Docket Nos. 50-10, 50-237, 50-249;  
50-254, 50-265; 50-295, 50-304;  
50-373, 50-374; 50-454, 50-455

We have completed our review of your draft Revision 4 to the generic portion of the Generating Stations Emergency Plan (GSEP) which was submitted to our office by letter dated July 1, 1983. The results of this review are enclosed as an appendix to this letter.

The following comments are being furnished regarding the draft Revision 4 to your Generating Stations Emergency Plan (GSEP) generic section. For the most part, these comments address spelling errors or clarifications that will make the document easier to understand; however, the first nine items identified with an asterisk (\*) are items which we feel if not revised as indicated below, will result in the downgrading of the effectiveness of your emergency plan and be in violation of 10 CFR 50.54(q) requirements if implemented without correction. Comments or required changes for each page of the draft are listed as follows:

Attachment: Flow Chart for General  
Emergency Offsite Protective Decisions

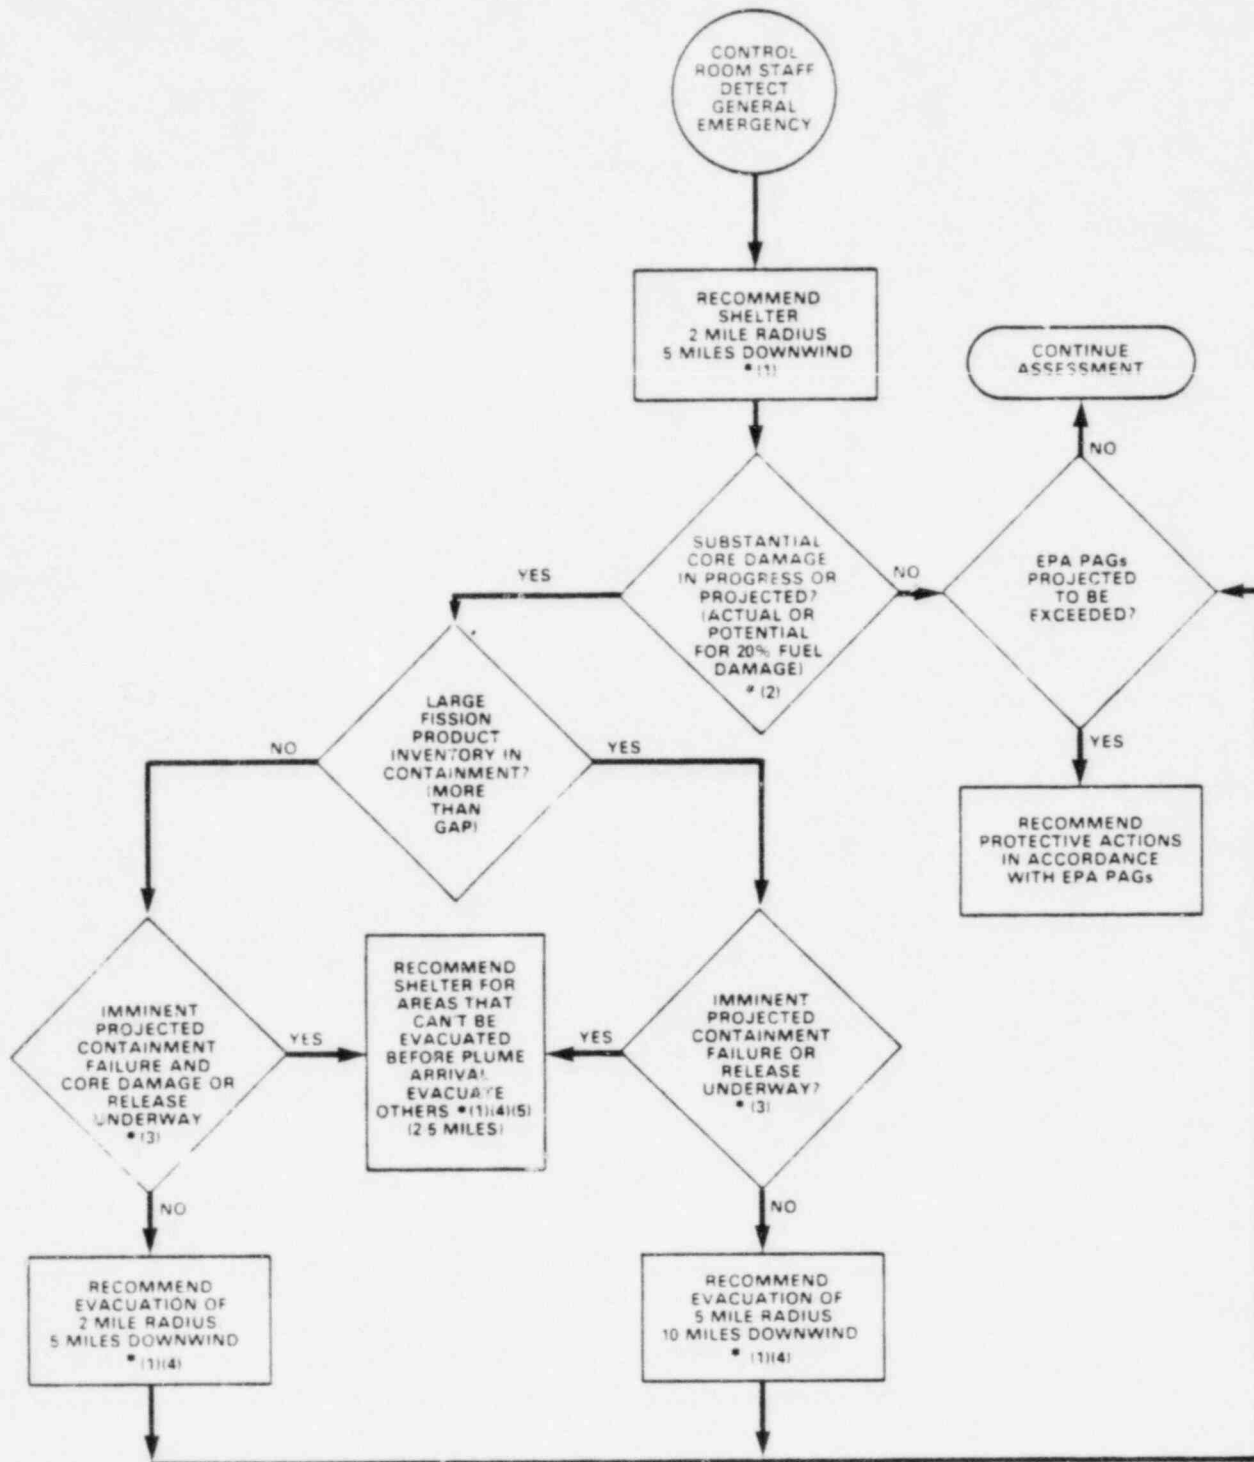
- \*5. Second page of Figure 6.2-1, "Actions from Control Room Indications and/or Plant Indications - Initial NARS Notification. The flow chart must be revised to allow the Shift Engineer to make these recommendations. Enclosed with this review is the chart issued in IE Information Notice 83-28. Please note that this chart is different than that provided you by Mr. M. Phillips, in that it does not require an individual to determine whether actions can be completed prior to completion of evacuation, it defines the term "substantial core damage," and what is considered to be a large fission product inventory in containment. This later term can be directly related to your containment radiation monitor reading based on time after shutdown. Using the flow chart shown on page 2 of Figure 6.2-1, the revised boxes must be marked as follows:

- a. Below the box labeled initiate calls to CECO for activation of TSC/EOF, the core damage box should read: "Is core damage (actual or projected release of 20% gap activity from the core) in progress or projected?"

- b. Delete the box below "core damage" (labeled TSC/EOF perform ODCS calculations as the following are evaluated).
  - c. If the answer to a. above is yes, the next box directed is the one labeled "Is there large fission product inventory in the containment?" This box should be relabeled as follows: Does containment radiation level indicate large fission product inventory in containment (e.g., greater than gap activity)? This should be a specific value time dependent on time after shutdown, and would start with the value labeled point 2 on the graph included in each GSEP annex and referenced in section 6.2.4 of the generic GSEP.

- d. If the answer to c. above is no/unknown, the next box should be relabeled as follows: Is containment failure and core damage projected to be imminent or is a release underway? (Containment failure can be further defined as greater than 280 degrees fahrenheit or greater than 61 psig for example using the Dresden set of EALs.)

- e. If the answer to c. above is yes, the next question should be the following: Is containment failure projected to be imminent or is a release underway? Again the same discussion as is given in d. above applies to the determination of what containment failure is defined as.

- f. If the answer to d. or e. above are yes, then the protective action recommendation should be revised to read as follows: Complete and transmit: NARS form section 9, "x" C-H,J,K. Action Recommended: Evacuate 2 mile radius ASAP/ 2-10 miles downwind. (This would be the population with the most likely probability of being the most severely impacted).

- g. In all cases, the line from the protective action recommendation boxes should now be routed to the same box as that from the no/unknown result regarding substantial core damage, namely, to the box labeled "TSC/EOF perform ODCS calculations."
